Rhue

44

- 4 - Ms Irene Brandt [Written Submissions]
- 9 - Mr Barry Chislett [Written Submissions]
- 43 - Mr and Mrs Iain Roy [Written Submissions]

Extract from Proposals Map Rhue Inset

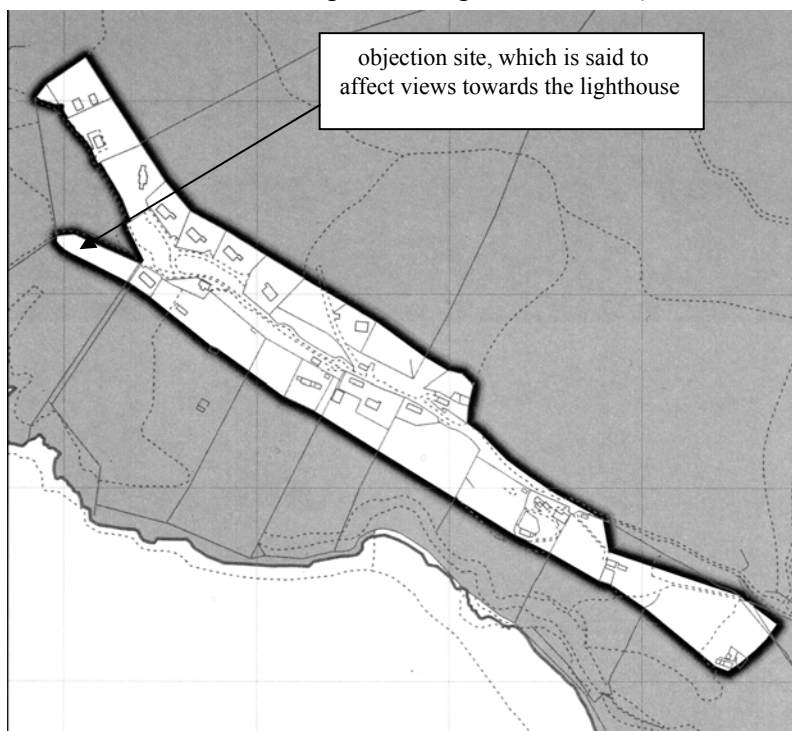
“• Access and views to the lighthouse at the west end should be maintained.

• Any development at the western end below the road must be single storey only.”

5. In particular, objections were raised against the potential for development to the south-west of the village, as this would obstruct views to the lighthouse; because this land projected out into an area of croft land; and because this would change the nature of the experience of visiting Rhue. The council’s suggested modification to reduce this area by half did not meet the objections. It was insufficient of the council to state that development on this land would be lower than the adjacent houses and would have no significantly detrimental effect on the views in this direction as even a single storey house on that site would have a detrimental effect on the views over the open water both for residents to the north of the road and for visitors approaching from the car park. Arguably, this was one of the finest viewpoints on the coast.

6. The open character of the settlement and the vista from the end of the road attracted many visitors both from the local area and tourists. Access to the lighthouse for maintenance had been accommodated in the past and would not be affected by improvement of the track, another reason cited for allowing development. Accordingly, there appeared to be no reason why the area to the south-west as shown within the Settlement Development Area, should not be removed from it entirely.

- (i) the boundary of the Settlement Development Area at the west end of the settlement be amended further in order to eliminate the objection site, as identified on the Proposals Map Rhue Inset (shown at paragraph 2 above); and
- (ii) Areas of Avoidance under Policy 1D (see chapter 21 above) be identified on the inset map to accord with the Landscape Capacity Study, both at the west end of the settlement and to the south of the settlement, and the Settlement Development Area boundary be adjusted accordingly.
